REQUEST FOR PROPOSALS

MAGNOLIA SCIENCE ACADEMY-1 CABLING SERVICES

Amended with red highlights for the changes and the Q/A section added on last pages

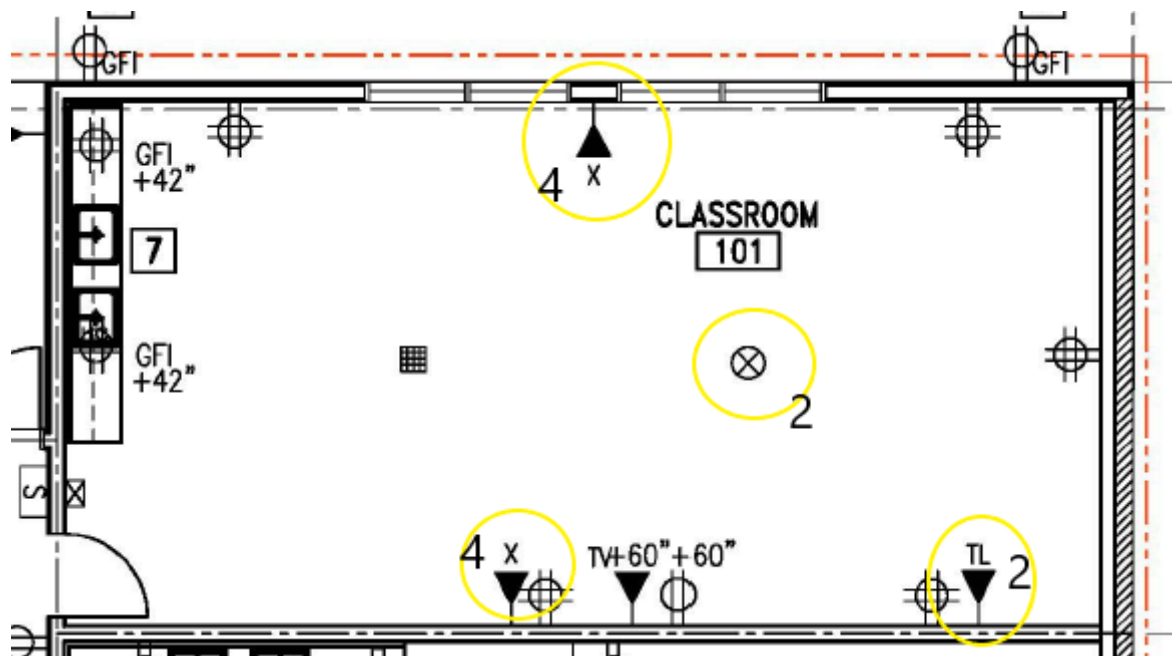
In addition to the site walk question – the RFP calls for 110 drops. But the count on the floor plans between A1.3 and A2.3 are 284.

Can we clarify that these notations I made are correct – i.e. this classroom has 12 drops in it.

4 for each quad outlet, 2 for TL 2 for the ceiling AP

The drops per classroom:

2 on teacher's corner, 4 on opposite side (Quad plate), 1 for Access Point on ceiling and 1 on teaching wall = Total 8 instead of 12 drops on blueprint
